# Power

Sheet: /Power/  
File: Power.kicad\_sch

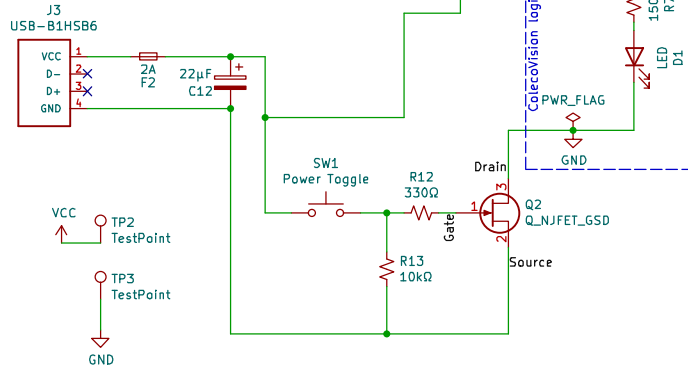
Revised Jan 2022:  
Removed barrel jack and reverse-polarity protection diode  
for 5V USB-B jack (should make it easier to find a PSU as well)

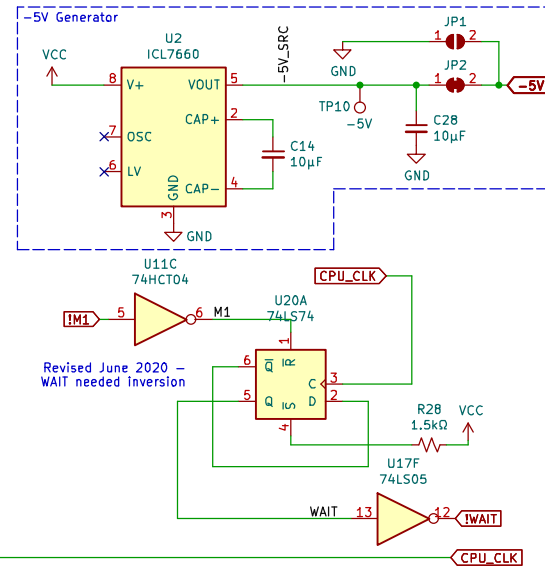
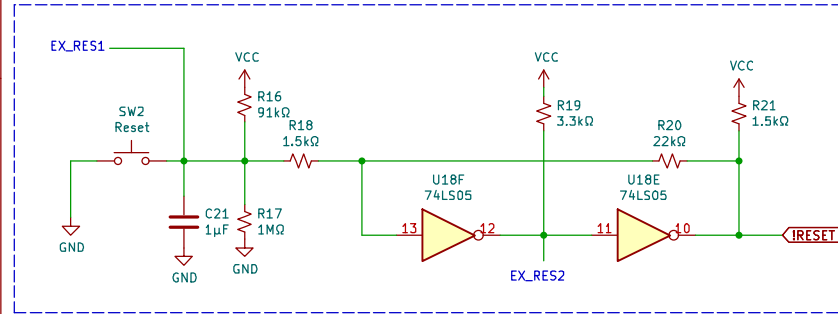
I dumped this entire mess and made an oscillator  
disperse directly to pin 11 of the new extra clock divider

this is about where U8 on the original schematic starts

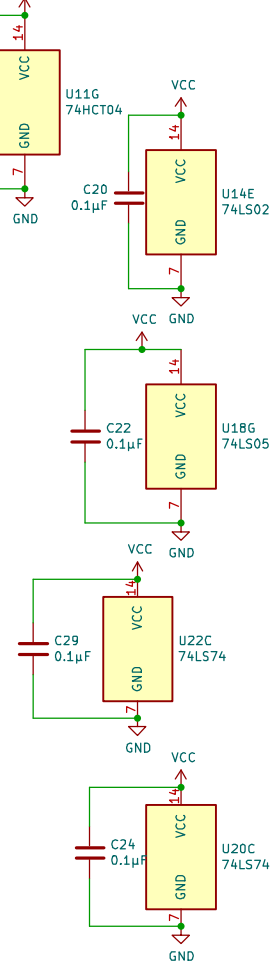
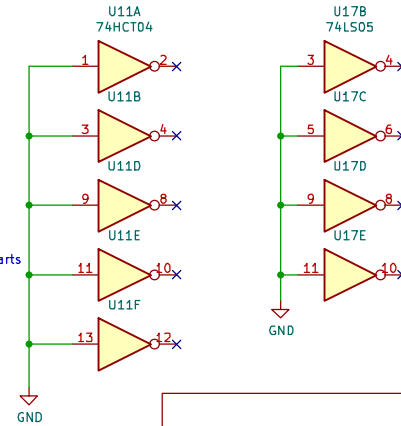
Revised June 2020 – transistor and other clock shift stuff removed,  
CPU clock tied to audio clock
